SERVICE BULLETIN

Service Bulletin No.: DAC1-74-03 Rev 2

Title: Installation of Optional Push-to-Start Ignition Switch

Figure 1 - Ignition Switch Installation

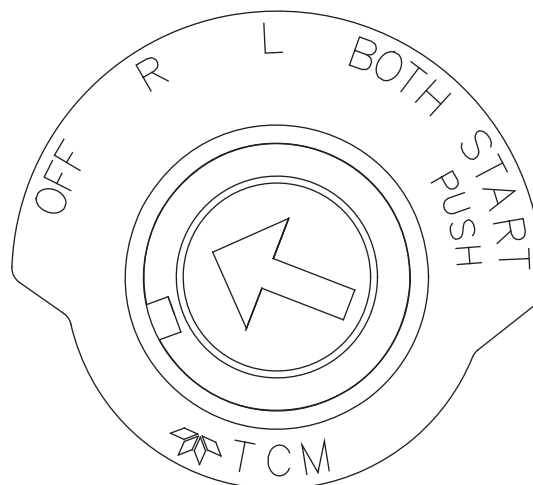
- 10.1 Disconnect the aircraft battery. Refer to AMM Chapter 24-31-00.
- 10.2 Remove the instrument panel cover. Refer to AMM Chapter 25-10-00.
- 10.3 Open the START circuit breaker located on the left side of the instrument panel.
- 10.4 Remove the existing ignition switch from the instrument panel. Refer to AMM Chapter 74-00-00.
- 10.5 Install the new ignition switch (PN 10-357210-1). Refer to AMM Chapter 74-00-00. Attach the wires as shown in Figure 1.

NOTE: Remove the existing ignition switch face plate and install the new face plate supplied with the new ignition switch.
